ORDERS UNDER SECTION 96 (2) OF ACT III OF 1910.

With reference to his application dated 1st Mar. 1912.
 Mr. Ismail Sahib Mahomed is informed
 that the plan submitted by him for building a house
 on plot No. 77 Survey Sheet K4
 situate in _____ Street _____

Building to be erected on plot N^o 77 - K. A. Lyaree Q^r -

Belonging to Ismail W^a Saleh mahomed

GROUND FLOOR

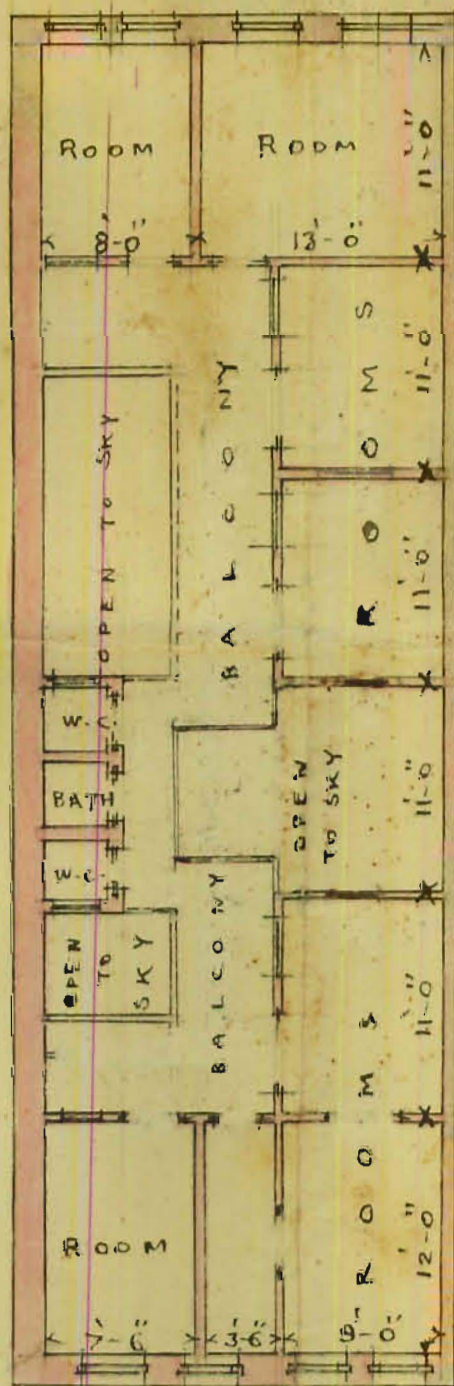
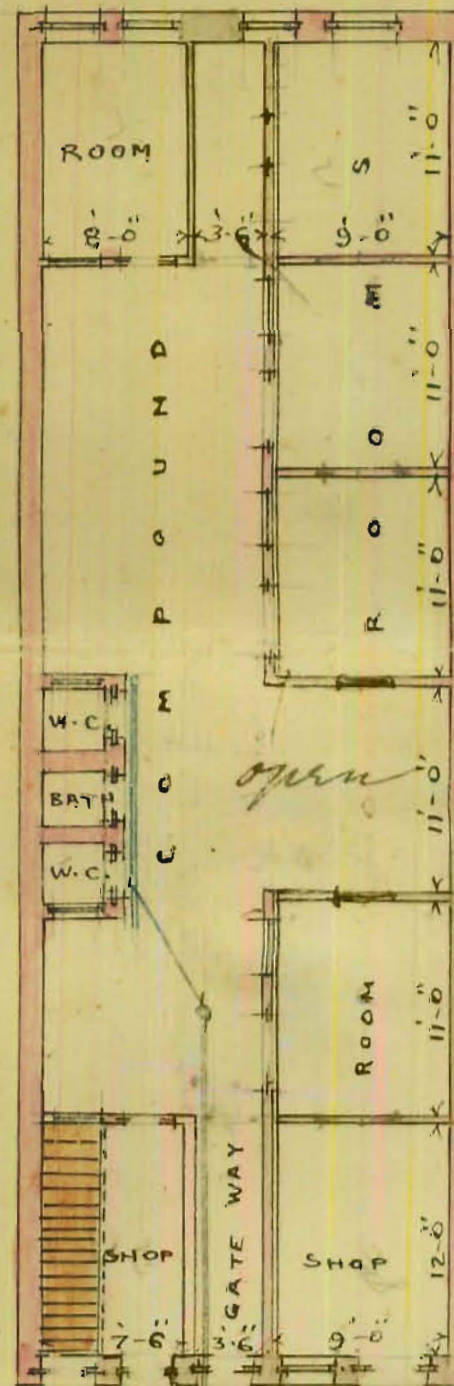
With reference to his application without date
Mr. Ismail Gallehmahomed owner of plot No. 77, K-4, Lyari quar-
ter is informed that his plan is disapproved. Some of the
down floor rooms are quite dark and absolutely uninhabitable.

With reference to his application dated 3rd instant, Mr. Ismail Gallehmahomed owner of plot No. 77, K-4, Layri quarter is informed, a room is shown over the water closets, which is objectionable and cannot be allowed under the Byelaws. If he deletes the room from the plan, his request for a pass will be considered.

With reference to his application dated 1st instant, with a plan for building on upper stories house on plot No.77, K-4, Lyari quarter, Mr. Ismail Salemahomed is informed, the rooms on the ground floor have insufficient light and air owing to the excessive width of the balcony above. Better arrangements must be made for the latrine accomodation ~~which~~ must not be placed above a living room on any account. The plan is disapproved and requires amendment.

Land Surveyor inform this applicant accordingly
Rooms are not well ventilated: room on the first floor, ^{right} above the r.e. Cannot be permitted
bedding room above the latrine accomodation cannot be permitted
14/13
15-2/13
No objection
Date 11-11-1912
11/13
S. W. Shroff.
D. P. H. (London,)
Health Officer,
Karachi Municipality.

Plan disapproved
The recommendation that there is no objection cannot be understood when some of the down flow from it don't will be quite dark and absolutely unsatisfactory

*They report that the man
has improved the plan pretty by
deleting one room from ground floor
and adding one room to the
first floor.*

One room has been deleted & left as an open space which has improved matters hence we see no objection to a pass being granted
